11.21.19 Design Commission Comments on Preferred Alternative

North Rainier Landbanked Park Development

North Rainier Landbanked Park Development Seattle Design Commission March 5, 2020

Park Site Plan

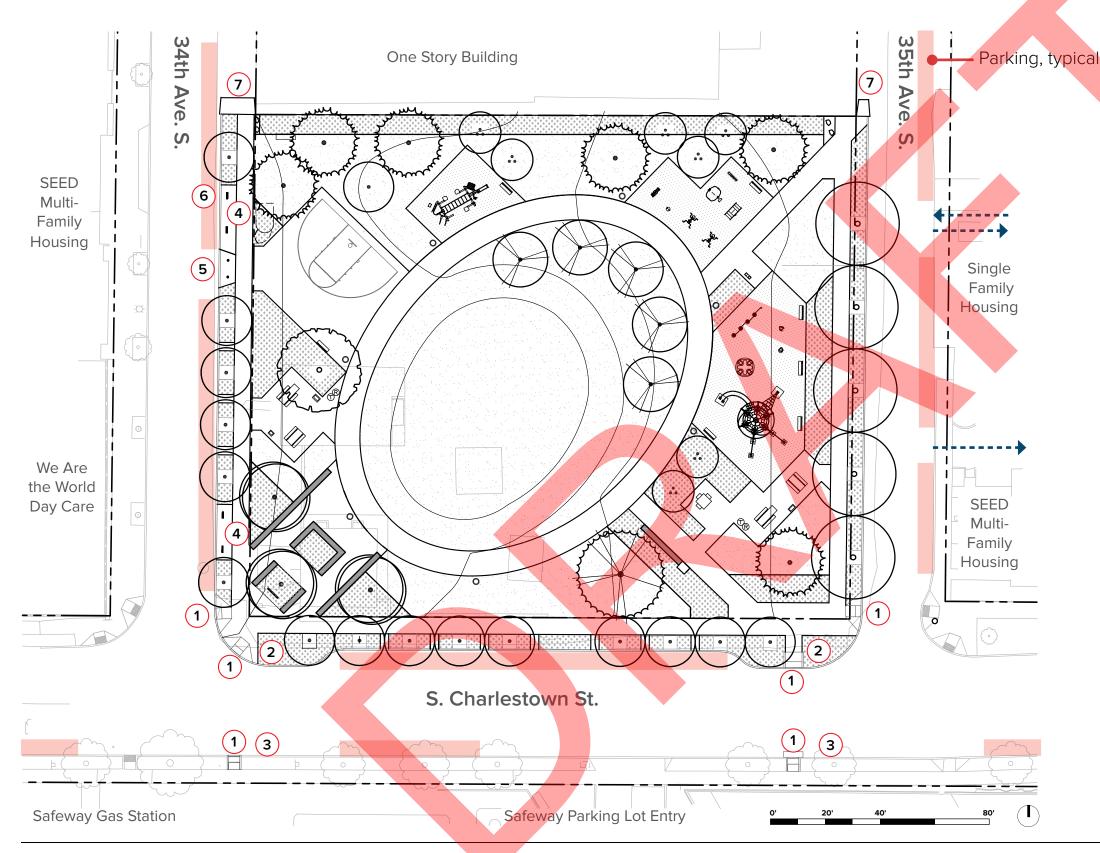
- Consider larger gathering spaces for family sized events.
- Continue to explore design options for the northern edge of the park including programming and planting that will provide a connection to future development.
- Consider adding a drinking fountain near play areas, to support active elements within the park.
- Seek opportunities for art and culture integration into the park that reflect community identity and goals.
- Think about naming of the park to reflect the history and culture of the neighborhood.
- Work with SDOT on opportunities to integrate cultural elements into sidewalk and crosswalks.
- Work with SDOT to implement crosswalks and other traffic calming measures on Charlestown to provide pedestrian friendly connections between the park and the commercial development.
- Consider sustainability in the selection and placement of site furnishings.

- A Family Gathering
- **B** Northern Edge
- c Drinking Fountain
- Integration of Art + Culture
- Naming of the Park
- Cultural Elements in ROW
- Traffic Calming on Charlestown
- H Sustainability for Site Furnishings

Right-of-Way

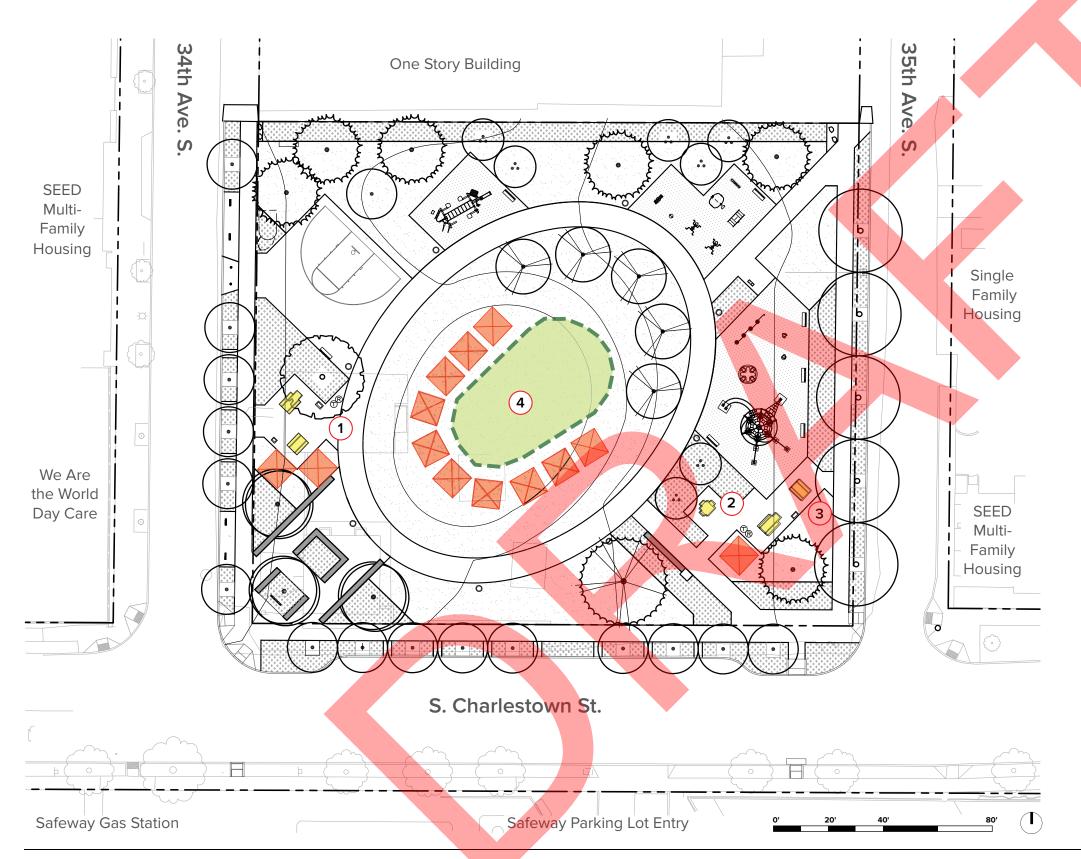
- F Cultural Elements in ROW
- G Traffic Calming on Charlestown

Proposed improvement on all street frontages include curb and gutter, a minimum 5.5' planting strip with street trees and understory, and a minimum 6' sidewalk.

Curb bulbs on both sides of S Charlestown Street provide traffic calming and connect to the commercial core. SDOT will fund curb bulbs on the south side of the street as part of this project (in development).

Site Use Diagram: Family Picnic

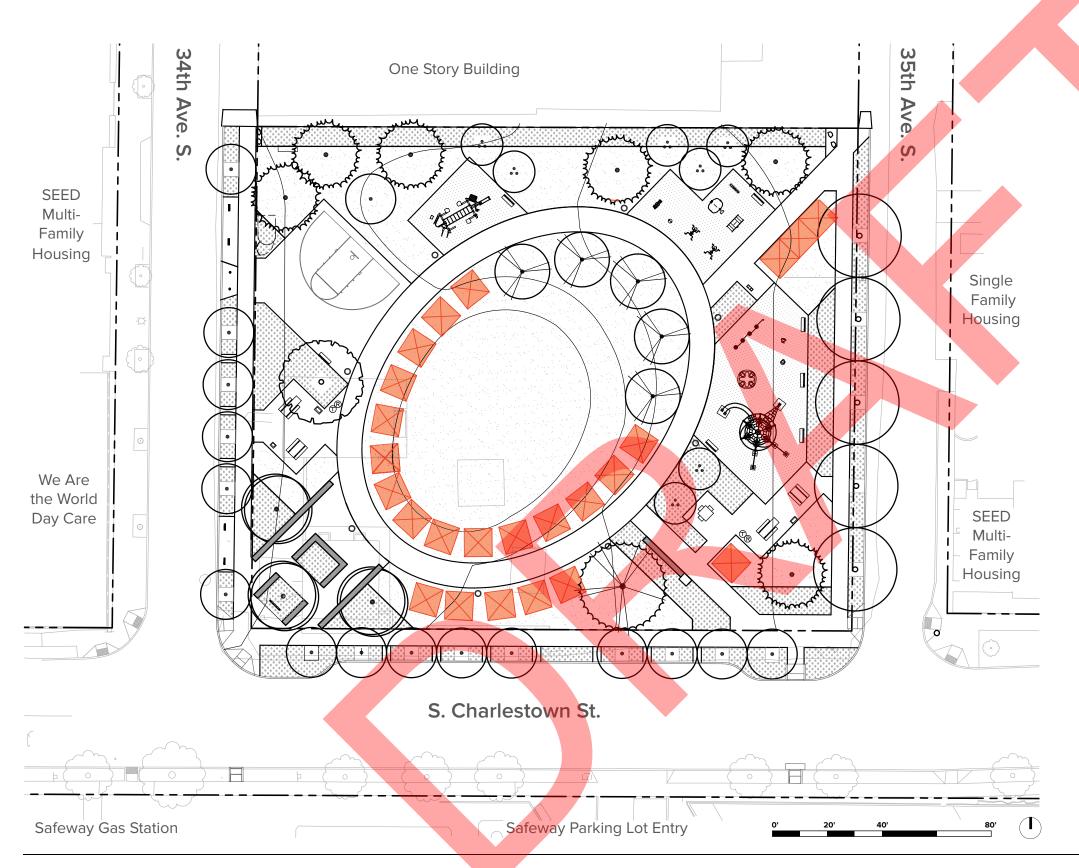
A Family Gathering

Family picnics and barbecues are a high priority for the neighboring residents as many of the nearby apartment complexes do not allow barbecues.

A variety of options are available for family picnics, including permanent facilities and adjacent lawn areas for additional canopies or activities
